Site Accessibility Evaluation

Eastside Library
1102 E Montecito St
Santa Barbara, CA 93103
Accessibility Evaluation
Inspection Date: 08/16/2023
Inspectors: Scott Saddlemire

Report Date: 11/03/2023

Finding: 1

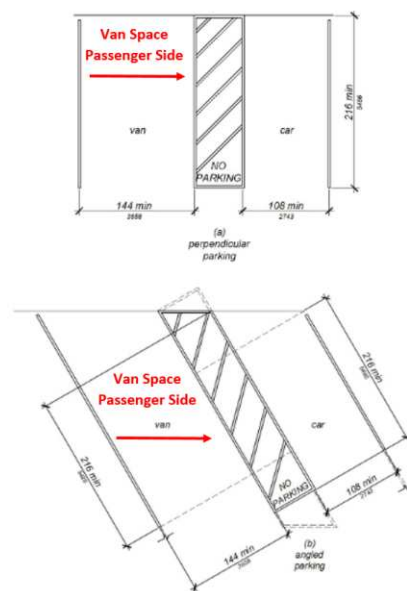
The access aisle is on the driver's side of the stall.

Access aisles must be located on the passenger side of the stall for van accessible stalls and must be 8 feet wide (measured center line to center line) by 18 feet long.

Van sign on regular stall,
detectable warnings

The accessible parking sign states that this is an accessible VAN stall. It is constructed as a regular accessible stall so the sign needs to be changed to a regular accessible stall sign

Finding: 2

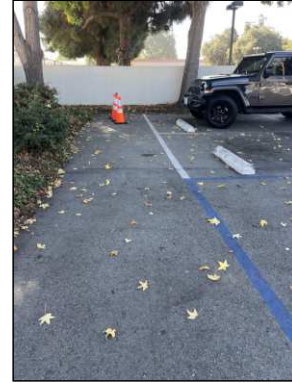
The required detectable warning surface is not provided at the parallel curb ramp.

Where the turning space has one entrance/exit point other than the sloped ramp segments, detectable warnings shall be 36 inches deep, as measured perpendicular to the curb, and the turning space shall provide minimum 36 inches wide portion without detectable warnings to allow pedestrian travel in the direction of the sidewalk without travelling over the detectable warnings.

All of the zero curb adjacent to the parking lot and the curb ramp needs detectable warnings

Finding: 3

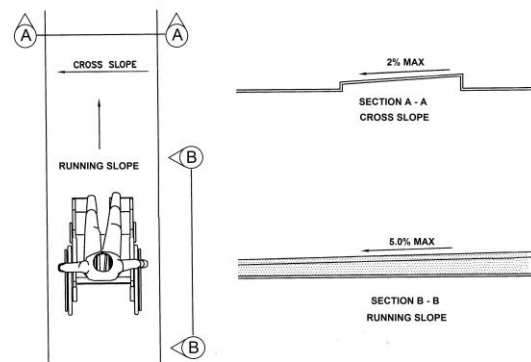
The accessible path of travel between the building and the public way on the site has cross slopes greater than 2%.

Surface cross slopes shall not exceed one unit vertical in 48 units horizontal (2-percent slope).

Finding: 4

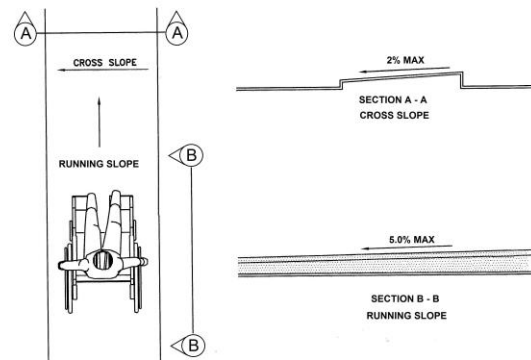
The accessible route on the site has running slopes greater than 5 percent and has not been constructed as a ramp (i.e. handrails, edge protection, etc.).

When the slope in the direction of travel of any walk exceeds 1 unit vertical in 20 units horizontal (5-percent slope), it must be constructed as a ramp. Surface cross slopes must not exceed one unit vertical in 48 units horizontal (2-percent slope).

Finding: 5

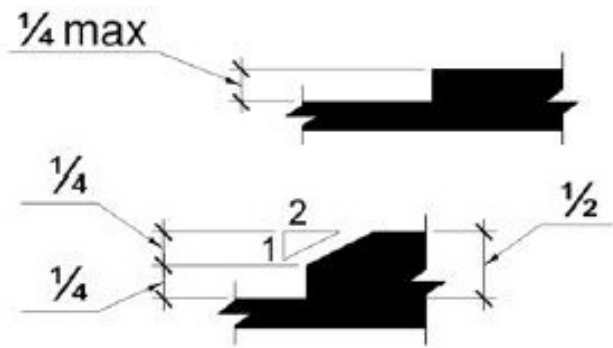
The walkway contains abrupt vertical edges and/or variations over 1/4 inch.

1/4 inch is the maximum vertical rise. Changes in level between 1/4 inch and 1/2 inch must be beveled at 1:2 or less.

Changes in level greater than 1/2 inch must be by way of a ramp.

Finding: 6

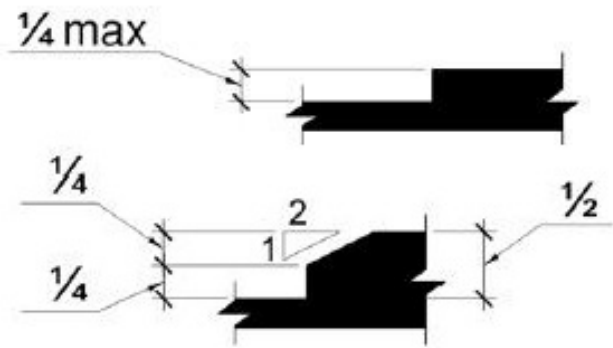
The walkway contains abrupt vertical edges and/or variations over 1/4 inch.

1/4 inch is the maximum vertical rise. Changes in level between 1/4 inch and 1/2 inch must be beveled at 1:2 or less.

Changes in level greater than 1/2 inch must be by way of a ramp.

Finding: 7

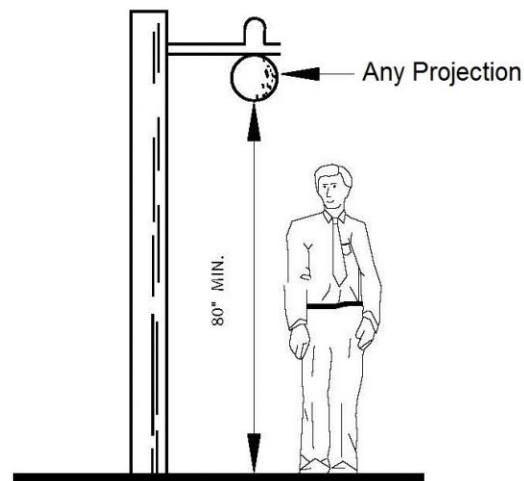
The element extends down too close to the route of travel.

Any obstruction that overhangs a route of travel must be a minimum of 80 inches above the walking surface as measured to the bottom of the obstruction.

Finding: 8

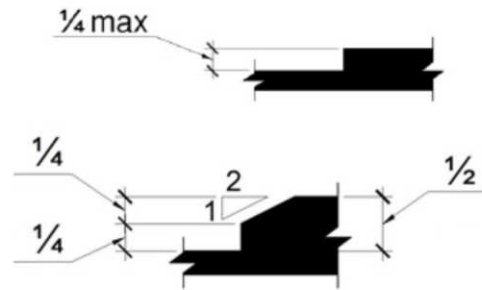
The walkway contains abrupt vertical edges and/or variations over a 1/2 inch.

1/4 inch is the maximum vertical rise. Changes in level between 1/4 inch and 1/2 inch must be beveled at 1:2 or less.

Changes in level greater than 1/2 inch must be by way of a ramp.

Finding: 9

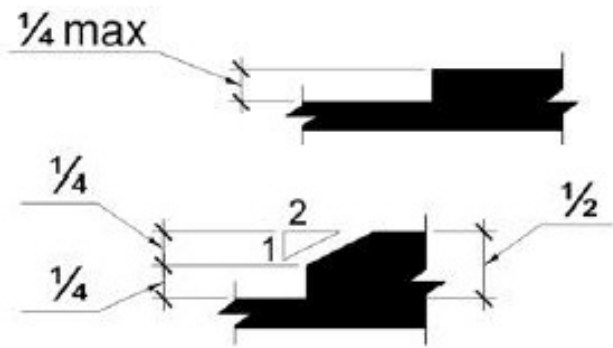
The walkway contains abrupt vertical edges and/or variations over 1/4 inch.

1/4 inch is the maximum vertical rise. Changes in level between 1/4 inch and 1/2 inch must be beveled at 1:2 or less.

Changes in level greater than 1/2 inch must be by way of a ramp.

Finding: 10

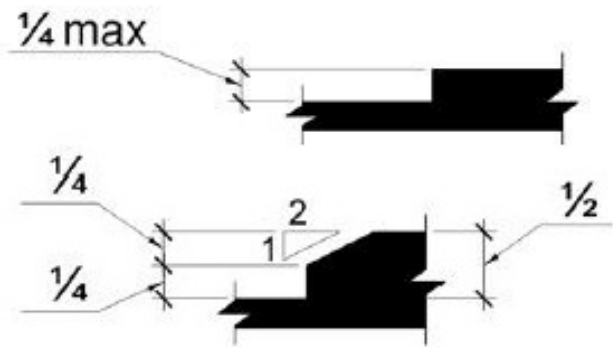
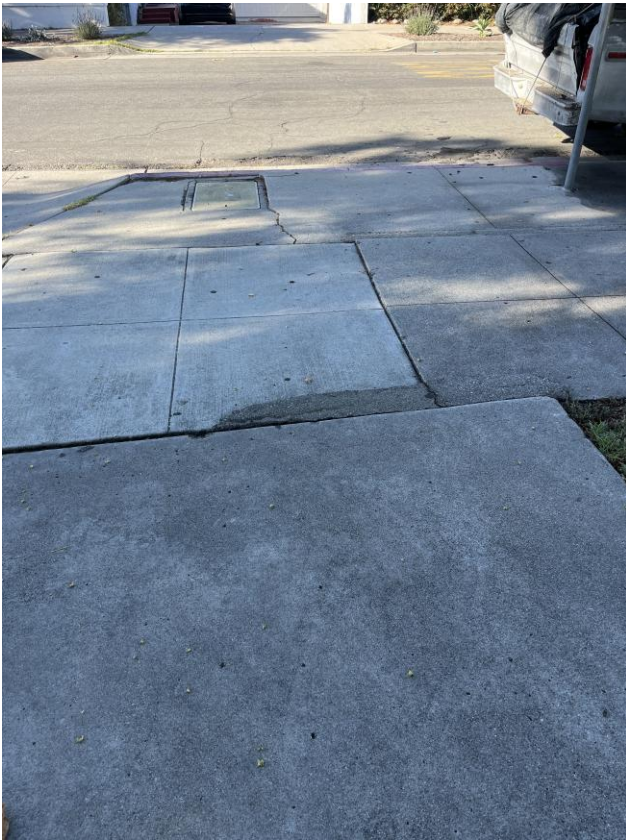
The walkway contains abrupt vertical edges and/or variations over 1/4 inch.

1/4 inch is the maximum vertical rise. Changes in level between 1/4 inch and 1/2 inch must be beveled at 1:2 or less.

Changes in level greater than 1/2 inch must be by way of a ramp.

Finding: 11

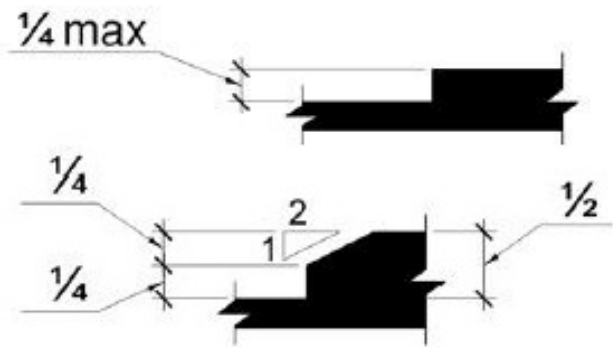
The walkway contains abrupt vertical edges and/or variations over 1/4 inch.

1/4 inch is the maximum vertical rise. Changes in level between 1/4 inch and 1/2 inch must be beveled at 1:2 or less.

Changes in level greater than 1/2 inch must be by way of a ramp.

Finding: 12

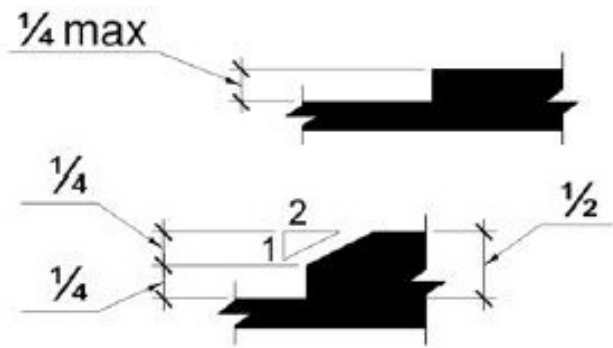
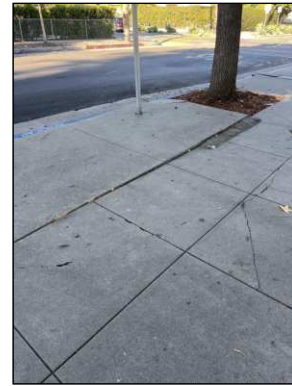
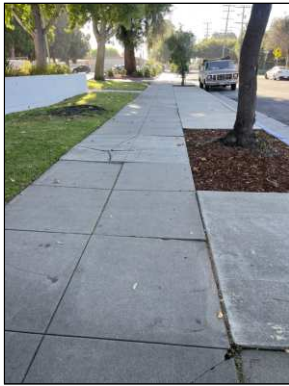
The walkway contains abrupt vertical edges and/or variations over 1/4 inch.

1/4 inch is the maximum vertical rise. Changes in level between 1/4 inch and 1/2 inch must be beveled at 1:2 or less.

Changes in level greater than 1/2 inch must be by way of a ramp.

Finding: 13

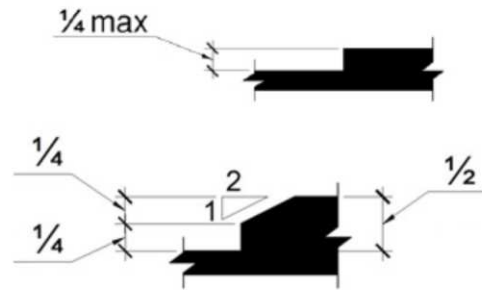
The walkway contains abrupt vertical edges and/or variations over a 1/2 inch.

1/4 inch is the maximum vertical rise. Changes in level between 1/4 inch and 1/2 inch must be beveled at 1:2 or less.

Changes in level greater than 1/2 inch must be by way of a ramp.

Finding: 14

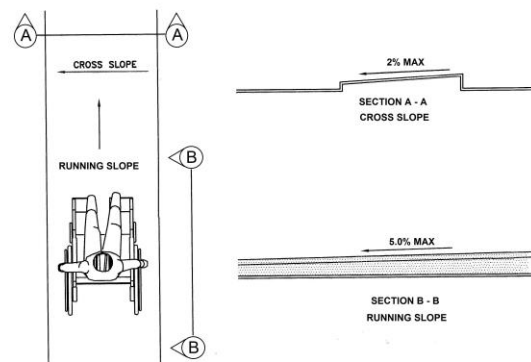
The accessible path of travel between the building and the public way on the site has cross slopes greater than 2%.

Surface cross slopes shall not exceed one unit vertical in 48 units horizontal (2-percent slope).

Finding: 15

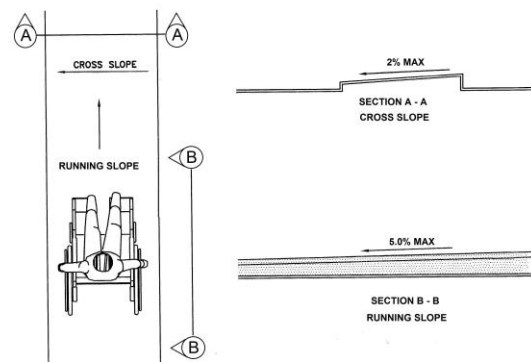
The accessible path of travel between the building and the public way on the site has cross slopes greater than 2%.

Surface cross slopes shall not exceed one unit vertical in 48 units horizontal (2-percent slope).

Finding: 16

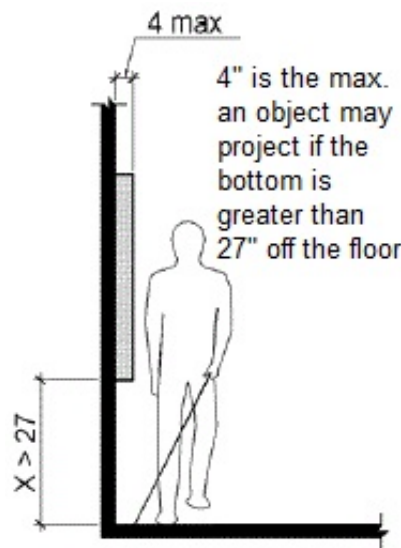
The element projects more than 4 inches into the circulation path.

Wall-mounted objects that have leading edges between 27 inches and 80 inches from the floor must not project more than 4 inches into the circulation path. Protruding objects that extend to the floor or within 27 inches of the floor are cane detectable and are therefore not hazardous. Where it is necessary or desirable to have objects protrude from the wall, a manner of cane detection must be provided.

Finding: 17

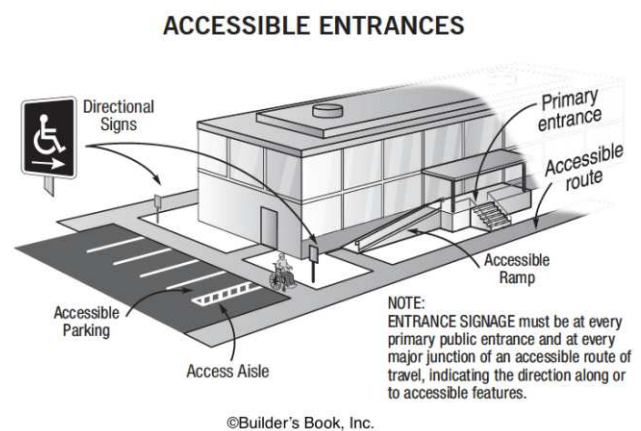
There is no accessible route to the accessible element.

At least one accessible route shall connect accessible buildings, accessible facilities, accessible elements, and accessible spaces that are on the same site.

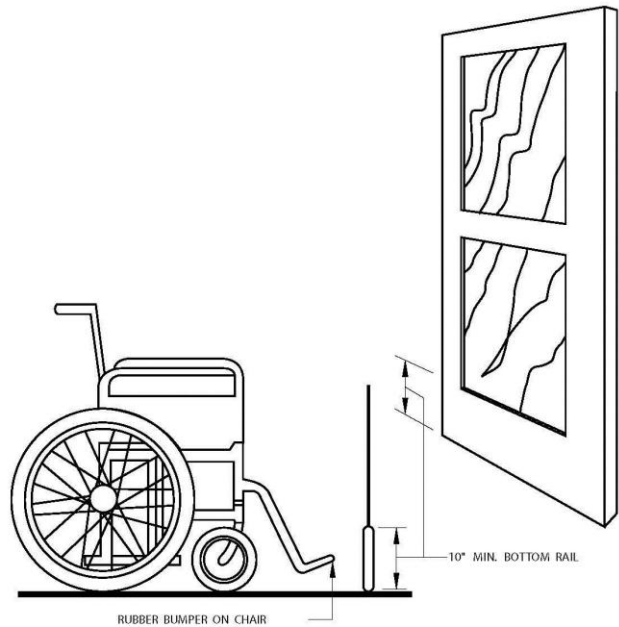
Swinging door surfaces within 10 inches of the finish floor or ground measured vertically must have a smooth surface on the push side extending the full width of the door. Parts creating horizontal or vertical joints in these surfaces shall be within 1/16 inch of the same plane as the other. Cavities created by added kick plates shall be capped. This is required to allow those that use wheelchairs to use their footrests to push the door open without getting trapped or injured by the gate material. All gates, including ticket gates, shall meet all applicable specifications for doors.

remove door stop

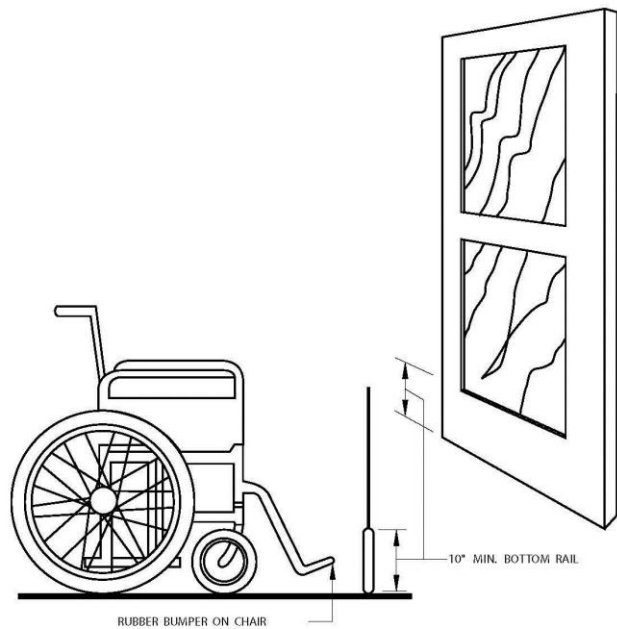
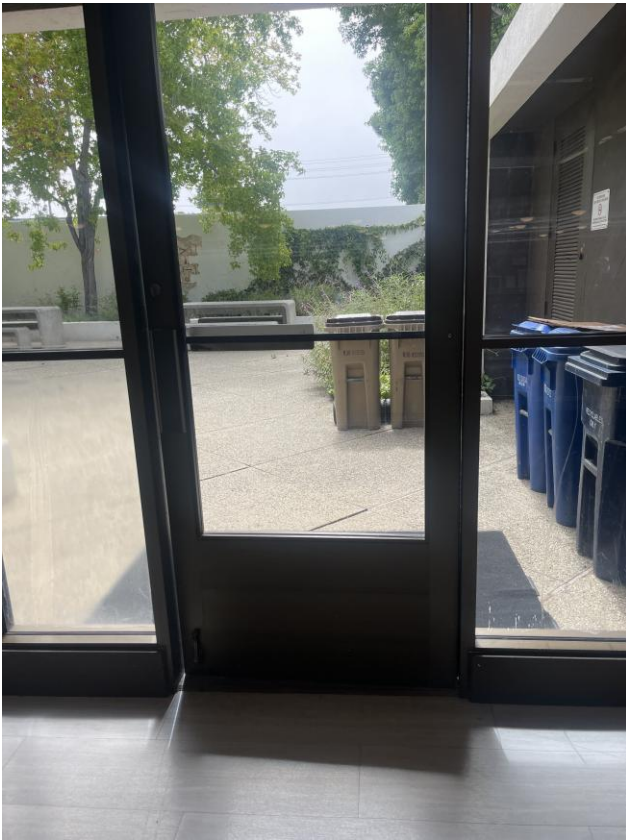
Swinging door surfaces within 10 inches of the finish floor or ground measured vertically must have a smooth surface on the push side extending the full width of the door. Parts creating horizontal or vertical joints in these surfaces shall be within 1/16 inch of the same plane as the other. Cavities created by added kick plates shall be capped. This is required to allow those that use wheelchairs to use their footrests to push the door open without getting trapped or injured by the gate material. All gates, including ticket gates, shall meet all applicable specifications for doors.

remove door stop

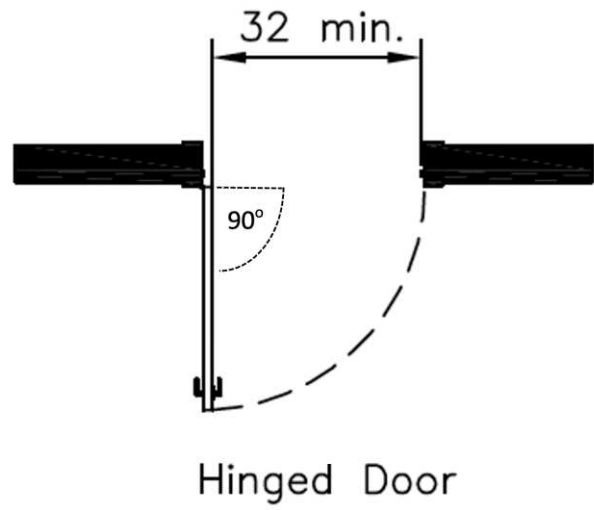
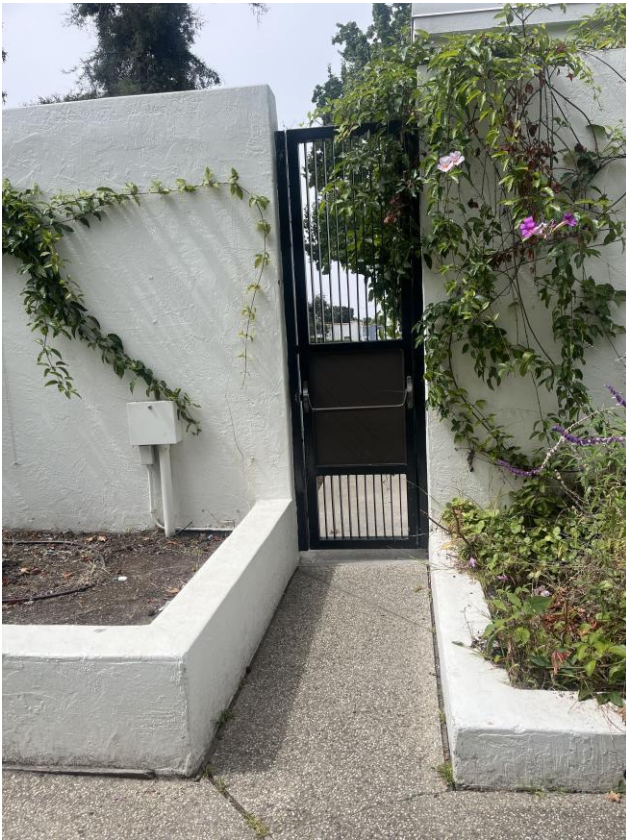
The door opening does not provide at least 32 inches between the face of the door and the opposite stop.

Door openings shall provide a clear width of 32 inches minimum. Clear openings of doorways with swinging doors shall be measured between the face of the door and the stop, with the door open 90 degrees.

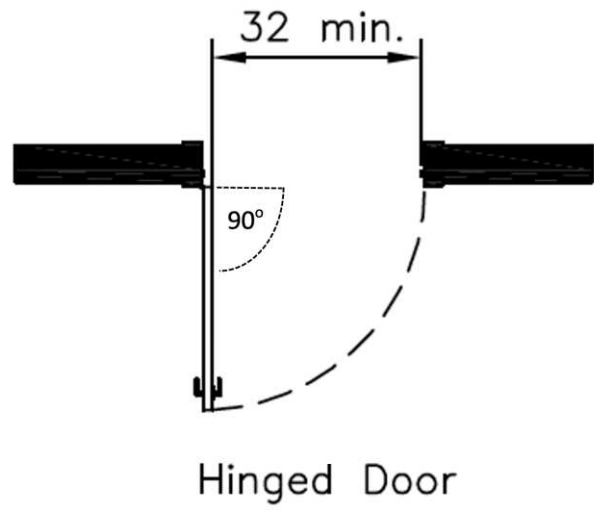
The door opening does not provide at least 32 inches between the face of the door and the opposite stop.

Door openings shall provide a clear width of 32 inches minimum. Clear openings of doorways with swinging doors shall be measured between the face of the door and the stop, with the door open 90 degrees.

appears to be a required exit

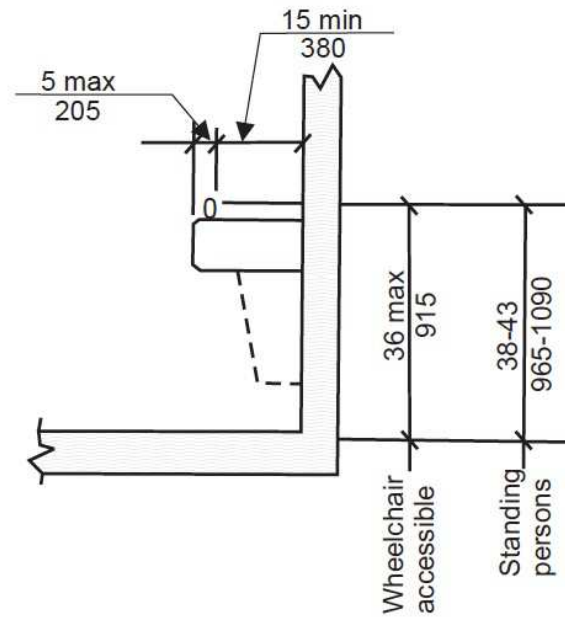
no standing person drinking fountain

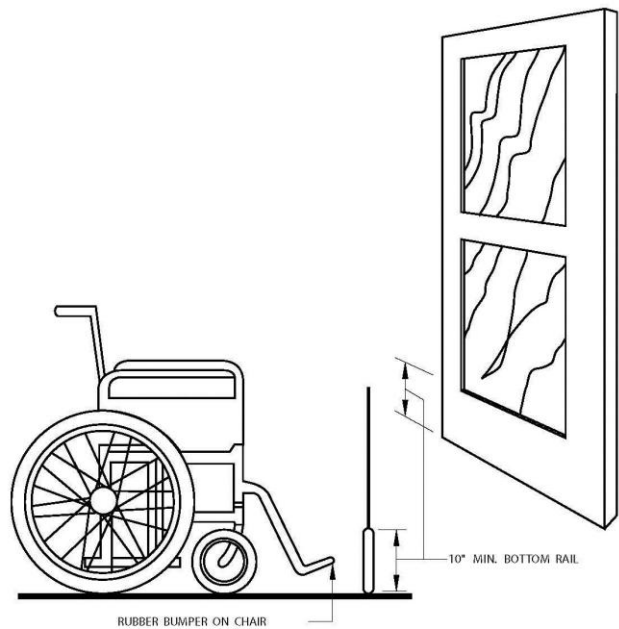
Swinging door surfaces within 10 inches of the finish floor or ground measured vertically must have a smooth surface on the push side extending the full width of the door. Parts creating horizontal or vertical joints in these surfaces shall be within 1/16 inch of the same plane as the other. Cavities created by added kick plates shall be capped. This is required to allow those that use wheelchairs to use their footrests to push the door open without getting trapped or injured by the gate material. All gates, including ticket gates, shall meet all applicable specifications for doors.

remove door stop

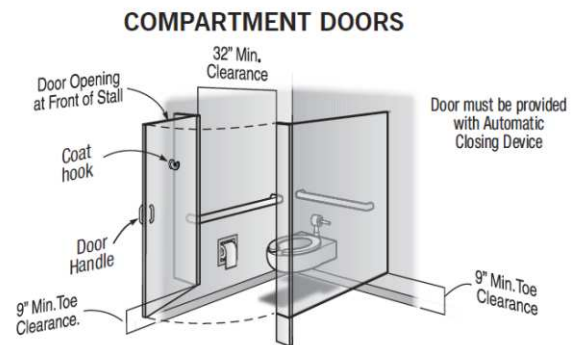
door not self closing

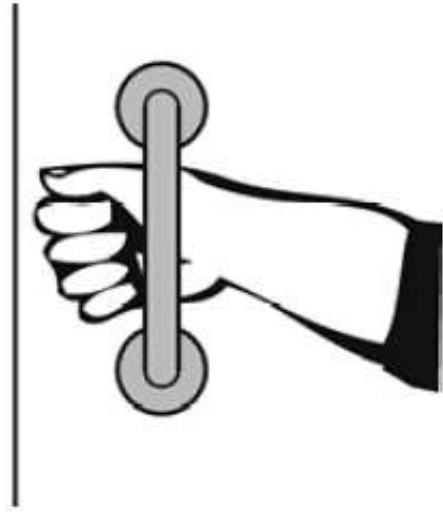
missing handle

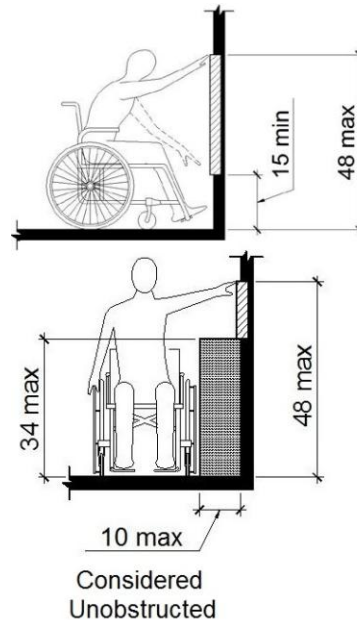
coat hanger too high

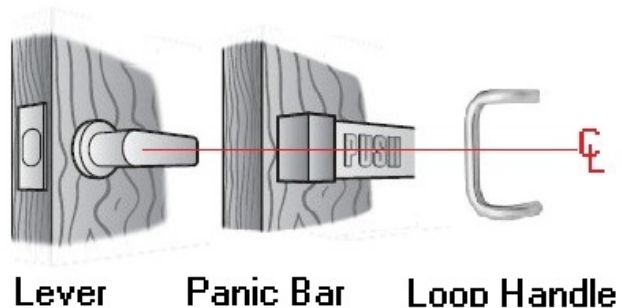
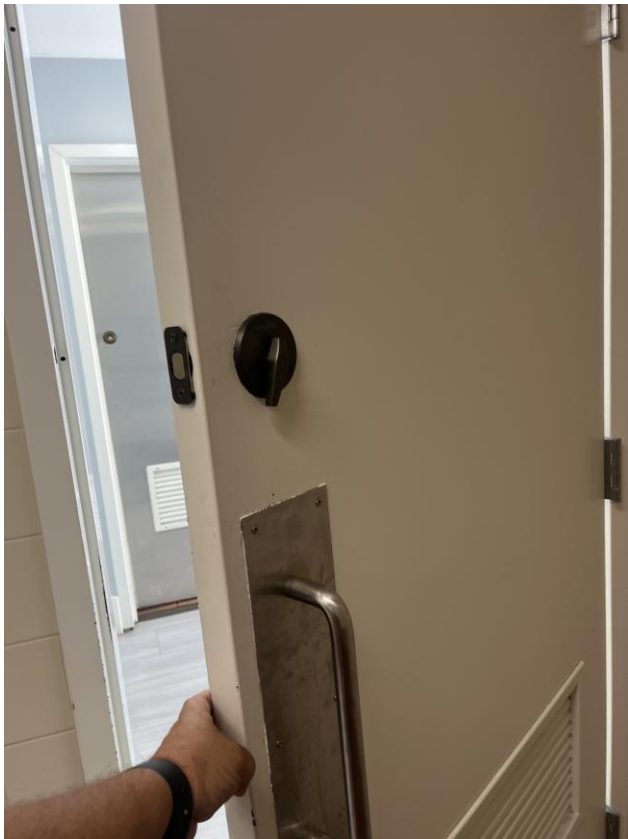
The door operating hardware is not located within the compliant range.

Hand-activated door opening hardware, handles, pulls, latches, locks, and other operating devices on accessible doors shall have a shape that is easy to grasp with one hand and does not require tight grasping, tight pinching or twisting of the wrist to operate. Hardware shall be centered between 30 inches and 44 inches above the floor.

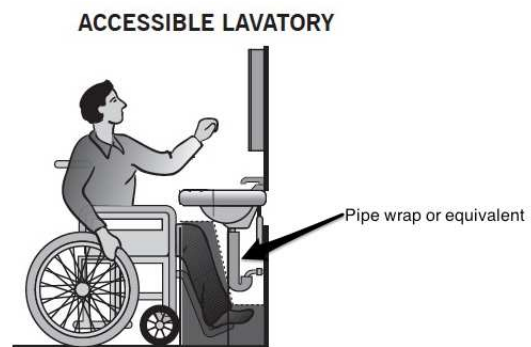
wrong side of door
